Page 1 is the existing concept plan used to establish numbers dated December 21, 2020.

# 51 WEST SUBDIVISION

## CITY OF STOUGHTON, WI

51 WEST SUBDIVISION PROPOSED UTILITIES

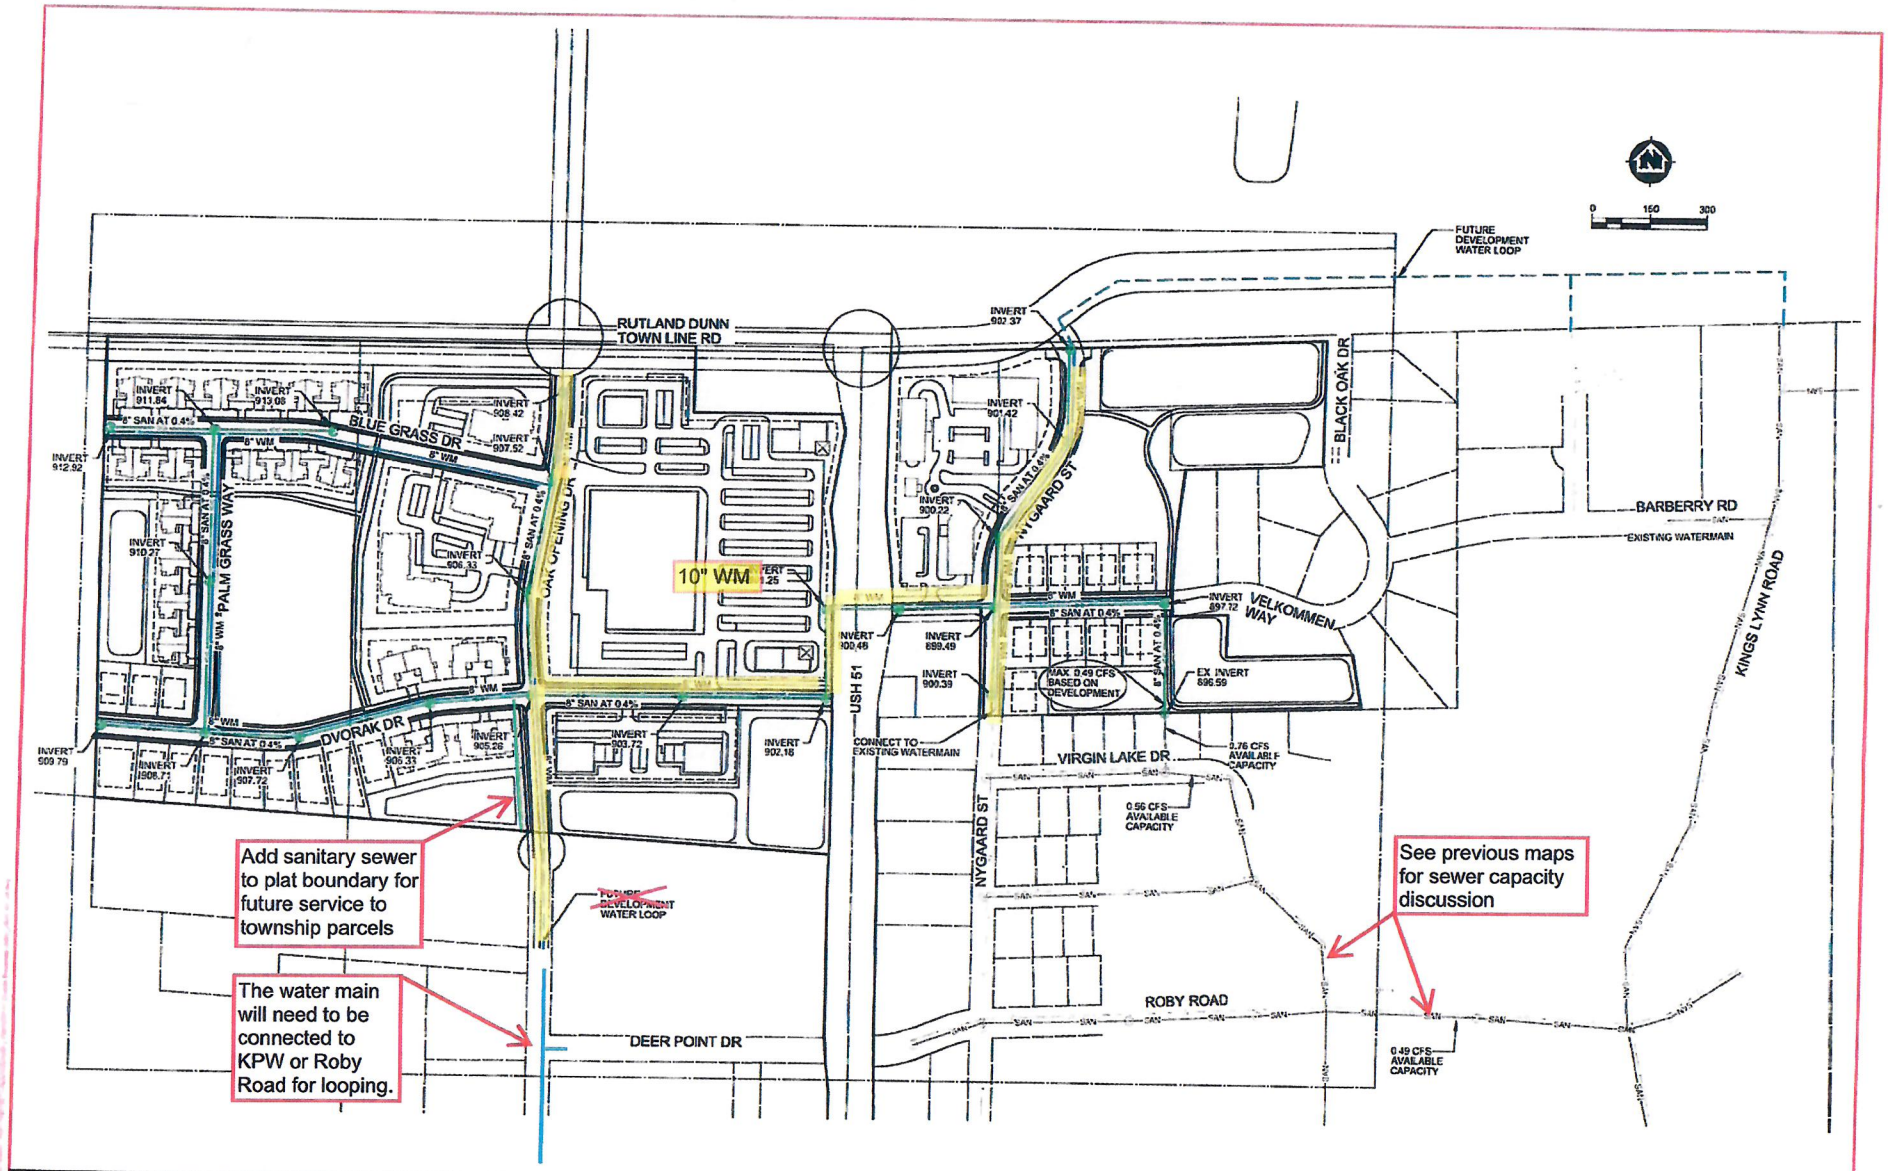
Page 2 Yellow highlighted indicates the change requested in early Dec. 2020 to change 8" water main to 10" for looping and future growth to the north.

Page 3

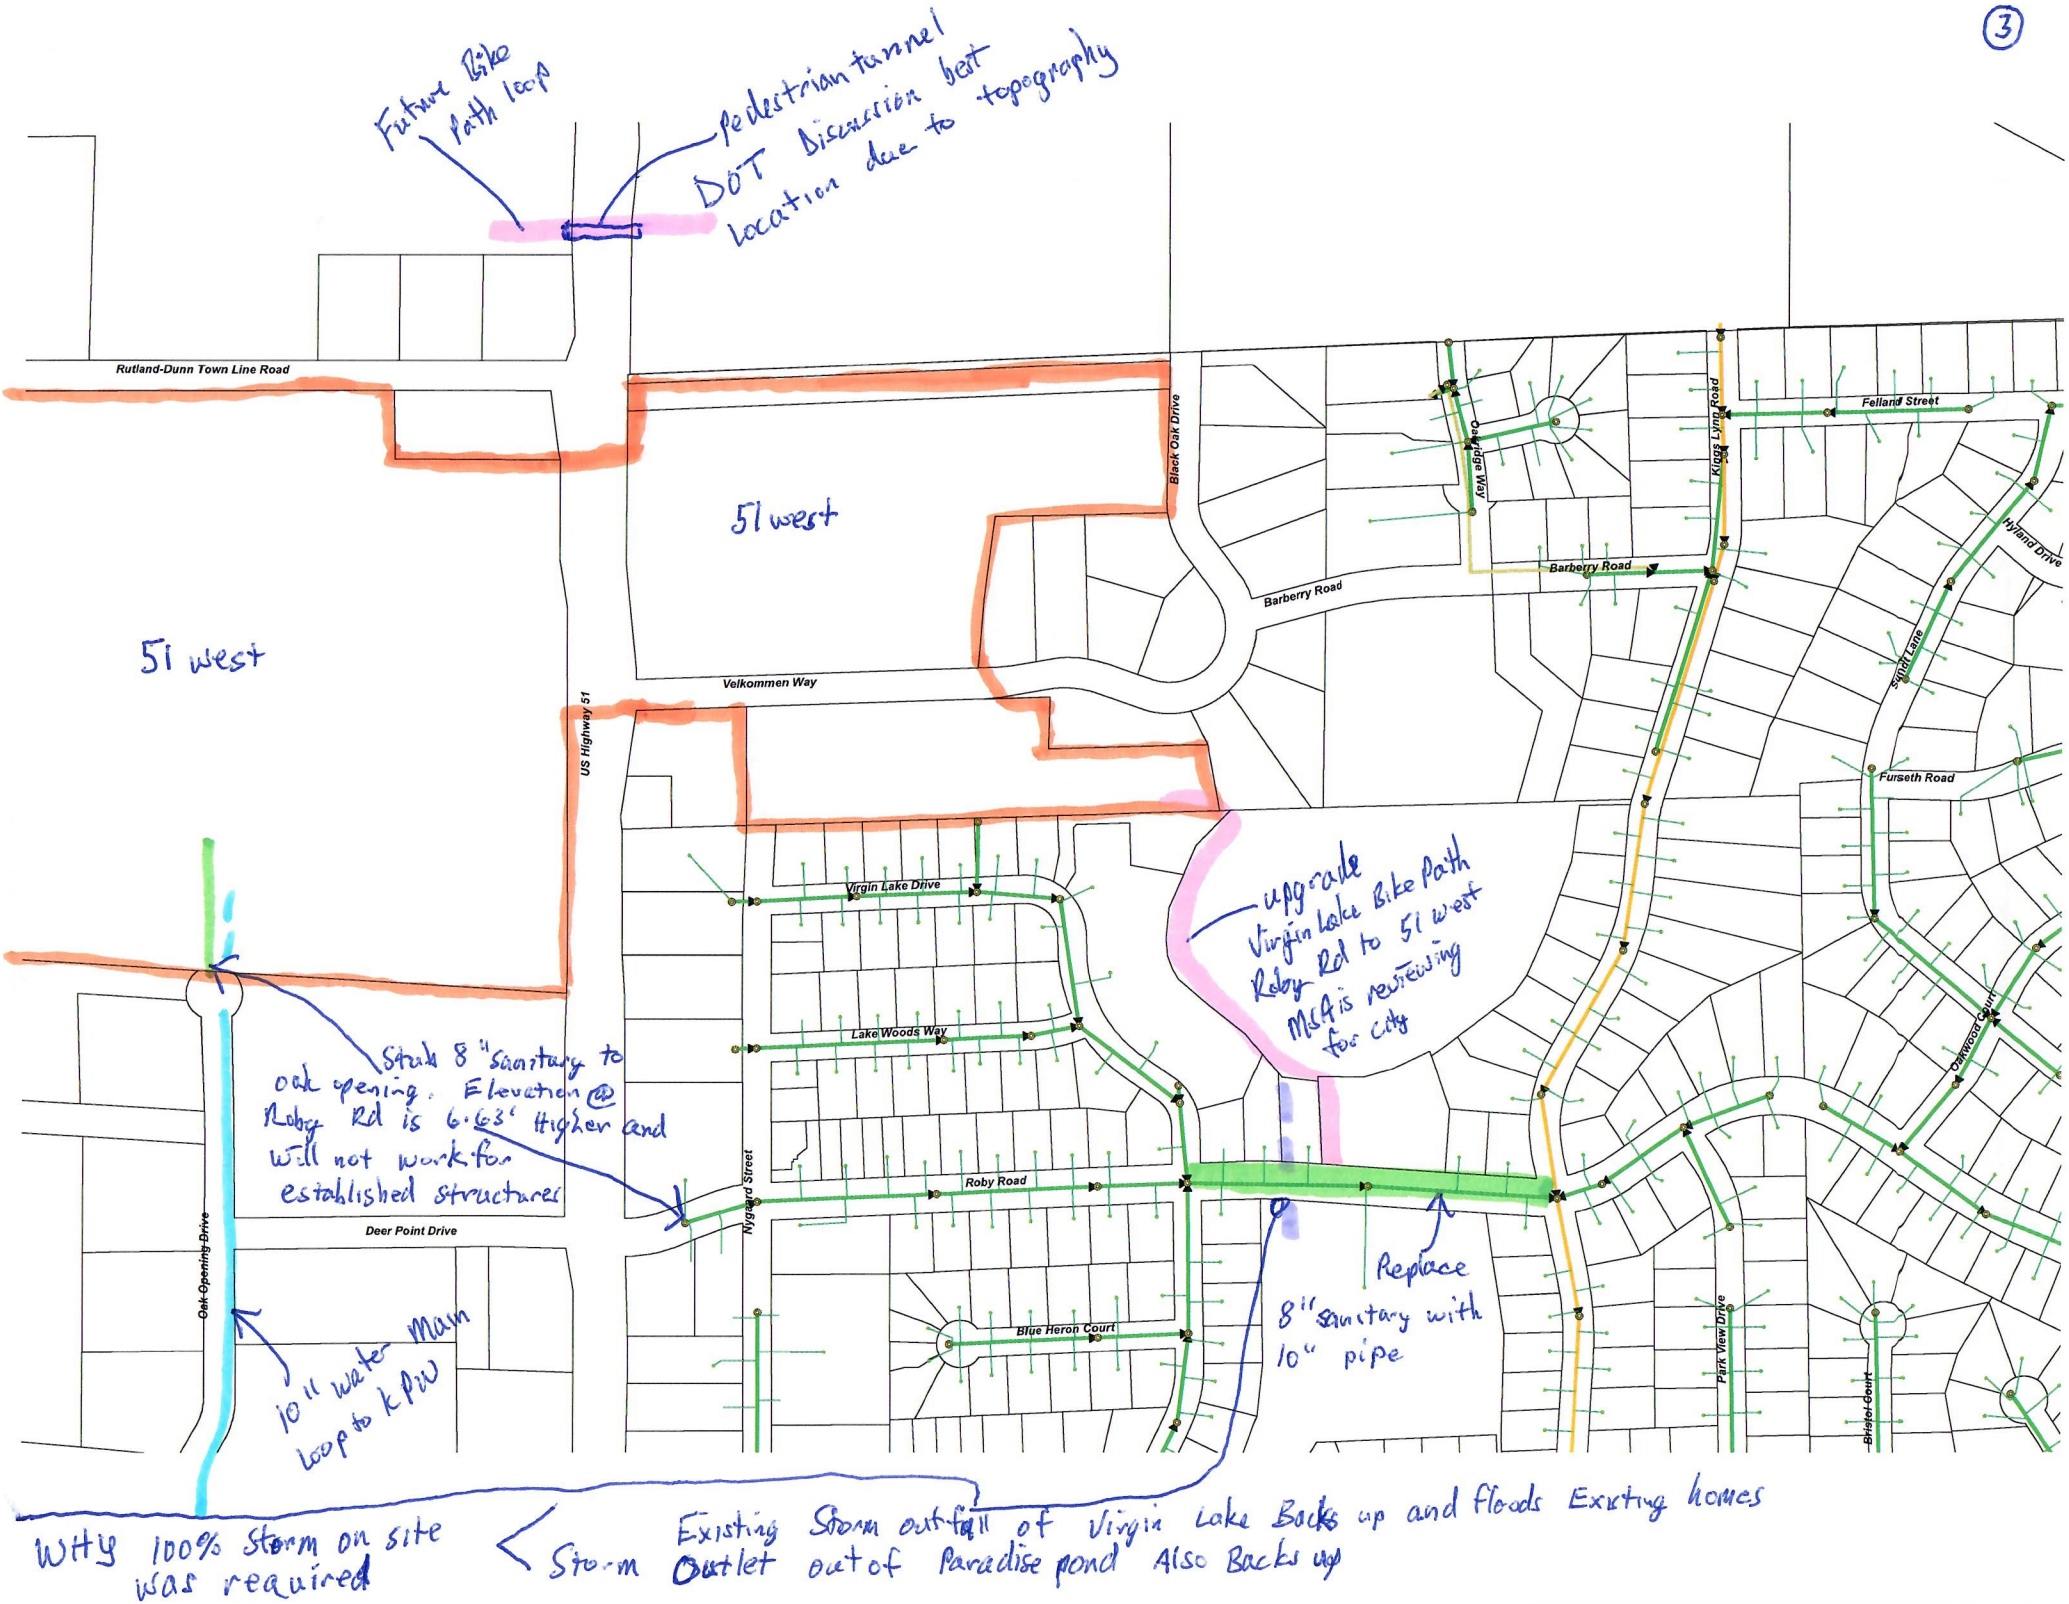
1. Indicates where DOT suggests installation of future pedestrian tunnel due to the topography along HWY 51 north.
2. Other pink highlighted area is a proposed new/upgraded bike trail from Roby Rd to 51 West, Jason you may want to check with your team there on progress of review. MSA is working directly with Parks on this scope of work.

3. Green highlighted north of existing Oak Opening indicates added sanitary due to elevation deficiency at Roby road (not deep enough to serve future customers on west side of HWY 51) gain 6.63' in depth thru 51 West.

4. Green highlighted Roby road sanitary between Virgin Lake Drive and Kings Lynn upgrade from 8" to 10" sanitary.
5. Blue Highlighted on Oak Opening drive indicates 10" water main loop to KPW development.

6. Purple highlighted discharge of Virgin Lake indicates an area where backup occurs and in turn flooding occurs from time to time at existing homes.
7. Downstream the storm outlet out of Paradise pond also backs up and the way I understand this backup at times streets flood.

8. Because of the deficiencies in items 6 @ 7 above 51 West development was required to either have 100% stay on site storm design or update the existing storm drainage from Virgin Lake to the Yahara River.
